Title - Sujet New Residence Nouvelle résidence	
Solicitation No. - N° de l'invitation EZ899-220930/A	Amendment No. - N° modif. 002
Client Reference No. - N° de référence du client	Date 2021-08-27
GETS Reference No. - N° de référence de SEAG PW-SPWY-031-9034	
File No. - N° de dossier PWY-1-44072 (031)	CCC No./N° CCC - FMS No./N° VME
Solicitation Closes - L'invitation prend fin at - à 02:00 PM Pacific Daylight Saving Time PDT on - le 2021-09-09 Heure Avancée du Pacifique HAP	
F.O.B. - F.A.B. Plant-Usine: <input type="checkbox"/> Destination: <input checked="" type="checkbox"/> Other-Autre: <input type="checkbox"/>	
Address Enquiries to: - Adresser toutes questions à: Leung, Janie	Buyer Id - Id de l'acheteur pwy031
Telephone No. - N° de téléphone (778) 919-3273 ()	FAX No. - N° de FAX () -
Destination - of Goods, Services, and Construction: Destination - des biens, services et construction: RCMP – New Residence – New Aiyansh, BC

This Amendment 002 is raised to extend the solicitation closing date and to issue Addendum #2.

New Residence
New Aiyansh, BC
Solicitation No: EZ899-220930/A

Project:	RCMP Employee Housing New Aiyanish		
Project No.:	211-02781-00	Addendum No.:	M01
Contract No

1 PARTIAL RCP
SK-01 SCALE: 1:50

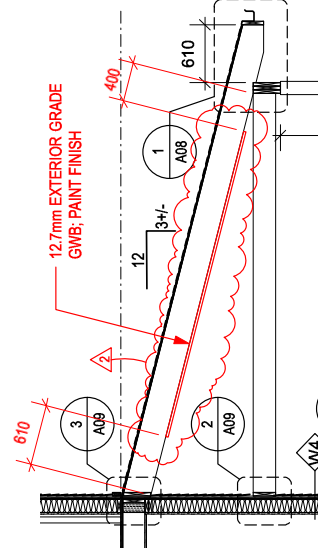
9. Clarification: Structural also shows a pair of 65x286 on each side of each post only. How is the exterior drywall to be installed that is shown on architectural?

1. Delete all notes on 1/A05 referring to wood framing at south canopy. Refer to Structural drawings for all canopy framing information. See attachment ASK-1 – this addendum.
2. Revise extents of exterior gypsum attached to underside of canopy rafters. See attachment ASK-1 – this addendum.

Response: The exterior gypsum board is to be fastened to the underside of the roof joists. See comments for Architectural Drawing A05 and attached SK-01.
